AXOD/AXODE (AX4S) UPDATE HANDBOOK

*Updated
October, 2002*

Since the introduction of the Ford AXOD transaxle in model year 1986, there have been many major engineering design changes that have affected many of the parts used in the AXOD transaxle. This version of the AXOD "Update Handbook" begins with the 1986 model year and will explain each change, the parts affected by the change, and any parts interchange problems created by the change. This booklet is an updated version of the original.

Figure 102

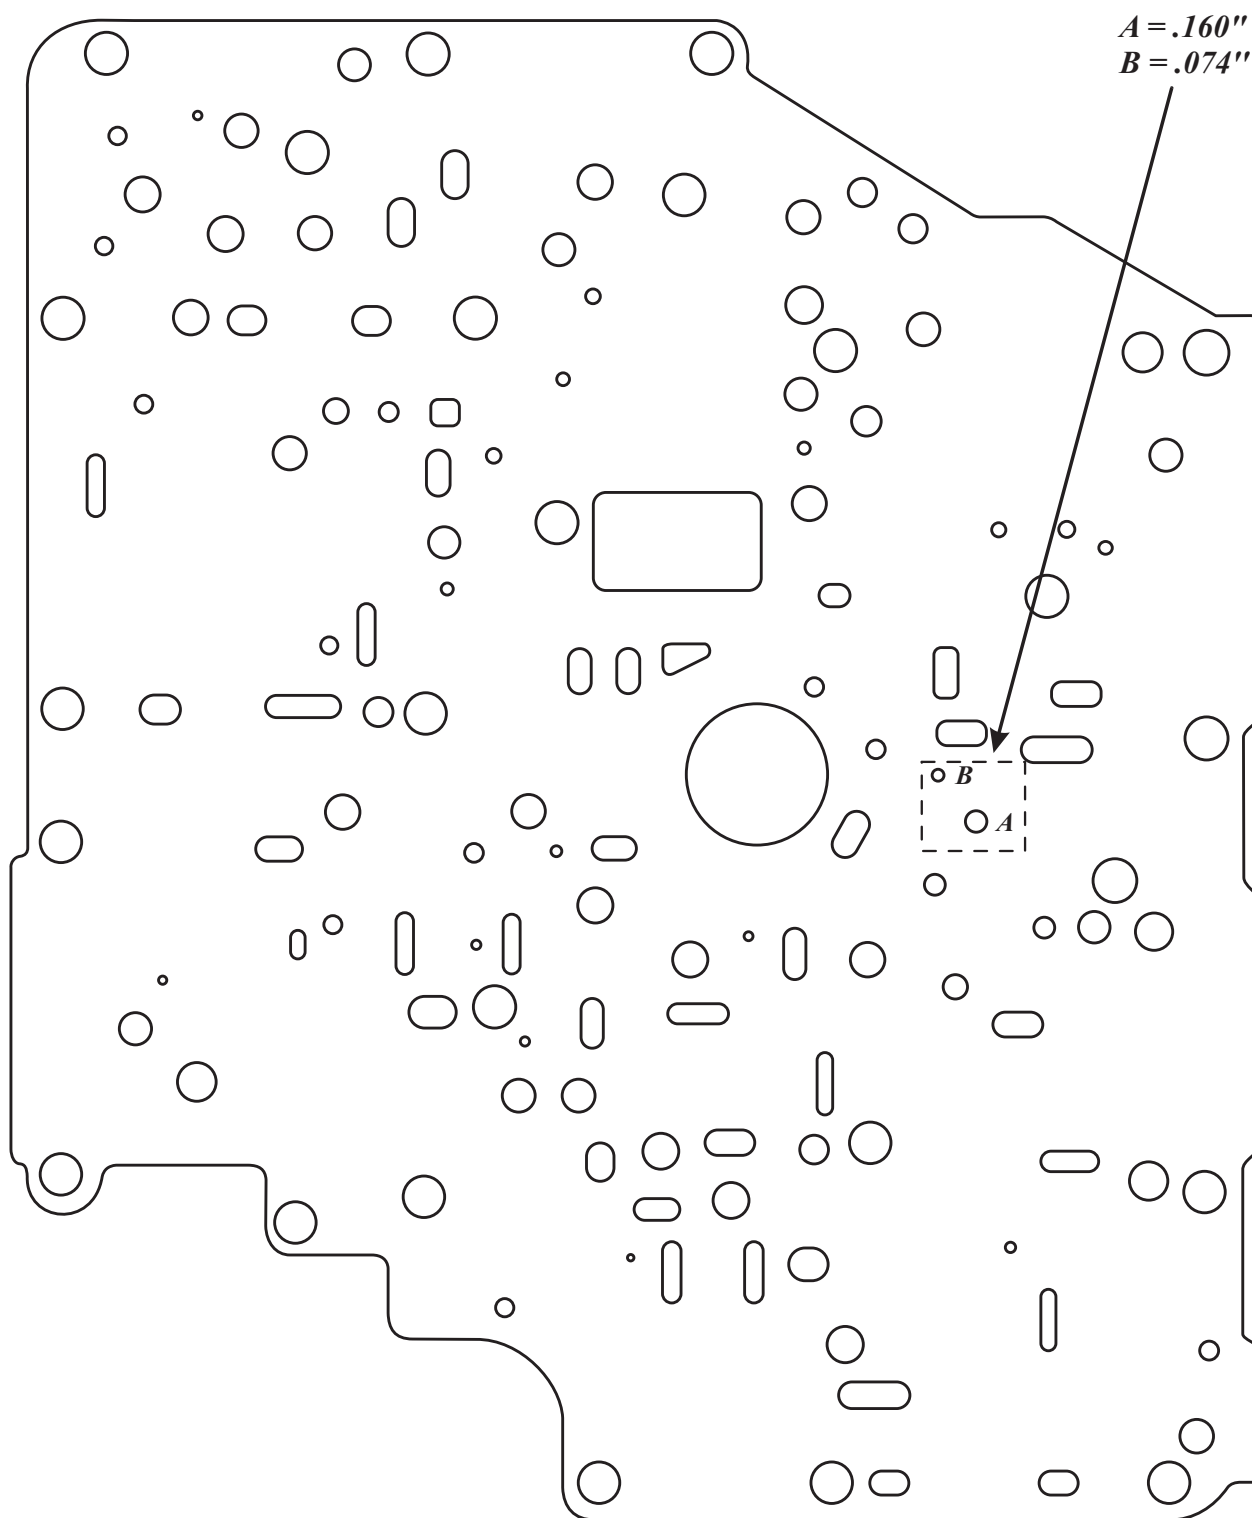
CORRECTION: Install the proper valve body spacer plate for the Ford family that you happen to be servicing at this time. Refer to the illustration in Figure 101 to identify the valve body spacer plate for the Windstar Van. Refer to the illustration in Figure 102 to identify the valve body spacer plate for the Taurus, Sable and Continental family.

Figure 103

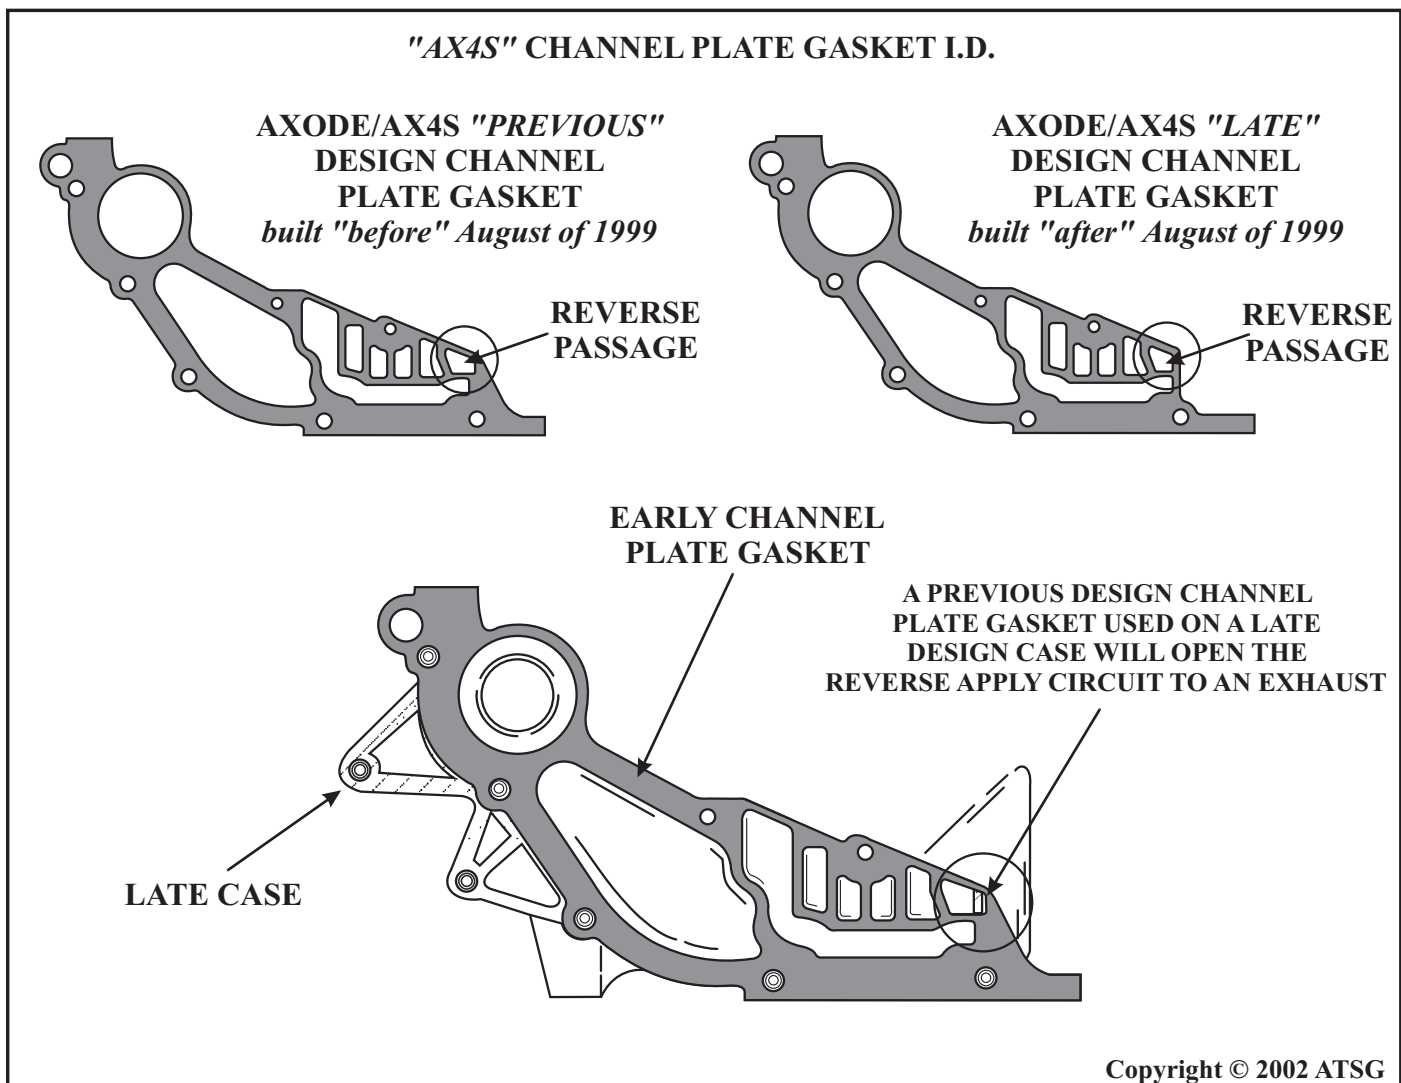
CAUSE: The cause may be, that the *Previous Design* Channel Plate Gasket, was used on a *Late Design* case as shown in Figure 103. When this happens, Reverse apply pressure will be exhausted back into the case because of the gasket hanging over the case casting.

CORRECTION: AX4S-Refer to Figure 103 to identify the correct Channel Plate Gasket for the application of vehicle you are working on.
AX4N-Refer to Figure 104 to identify the correct Channel Plate Gasket for the application of vehicle you are working on.
